PIONEER®

Service Manual

ORDER NO.
ART-621-0

A-5 HE, HB

Fig. 1

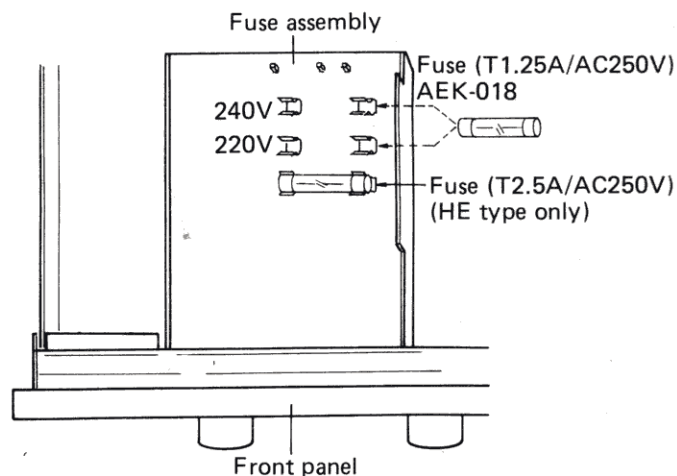
Line Voltage Selection

Line voltage can be changed with following steps.

1. Disconnect the AC power cord.
2. Remove the top cover.
3. Take out the fuse (AEK-018) from the fuse assembly.
4. Re-install the fuse in the correct voltage indication (see Fig. 1).
5. Stick the line voltage label on the rear panel.
